Access Compliance Report

Public Rights-of-Way

(Curb Ramps)

Intersection ID: 54302	Main Street: PROVIDENCE_FARM_LN	Cross Street: ARDREY_KELL_RD	Location: SW
ADA ID: 7029C004C473	Ramp Type: Directional1	Initial Pass/Fail: Fail	Overall Compliance: No
			Severity Score: 13.75

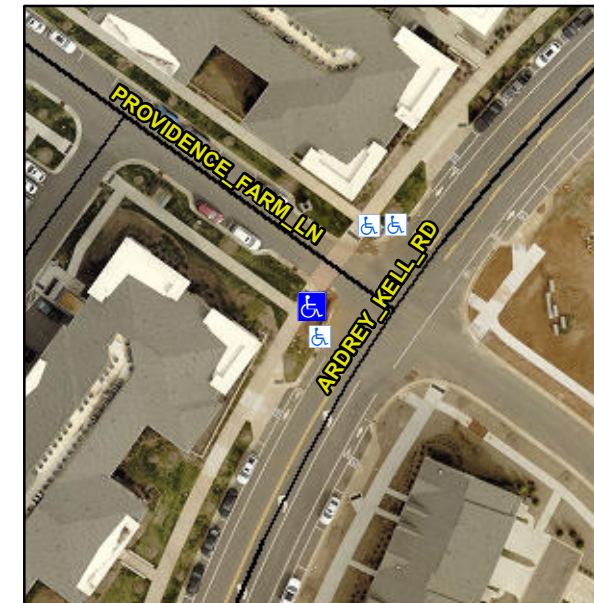
R304.2.2, R304.5.3

Compliance	Description	Data	Compliance	Description	Data
N/A	Ramp Length (in)	73.0	N/A	Grade Break?	N/A
Yes	Ramp Width (in)	90.0	N/A	Grade Break Slope (%)	0.0
No	Ramp Slope (%)	8.7	N/A	Grade Break XSlope (%)	0.0
No	Ramp XSlope (%)	2.9			
N/A	Flare Type LT	N/A	N/A	Flare Type RT	N/A
N/A	Flare Slope LT (%)	N/A	N/A	Flare Slope RT (%)	0.0
N/A	Flare Traversable LT?	N/A	N/A	Flare Traversable RT?	N/A
N/A	Landing Length (in)	0.0	N/A	DWS Provided?	N/A
N/A	Landing Width (in)	0.0	N/A	DWS Contrast?	N/A
N/A	Landing Slope (%)	0.0	N/A	DWS Length (in)	N/A
N/A	Landing X Slope (%)	0.0	N/A	DWS Full Width?	N/A
N/A	Landing Curb? (Y/N)	N/A	N/A	DWS Offset LT (in)	N/A
N/A	Shared Landing?	N/A	N/A	DWS Offset RT (in)	N/A
N/A	Gutter Ponding?	0.0	N/A	Gutter Slope (%)	N/A
N/A	Gutter Lip Ht (in)	0.0	N/A	Gutter X Slope (%)	N/A
N/A	Painted X Walk1?	No		Road Slope (%)	0.4
	X Walk 1 Direction	To NE		Road X Slope (%)	2.3
	X Walk 1 Width (in)	N/A		Clear Space?	N/A

Remove & Replace Entire Ramp.
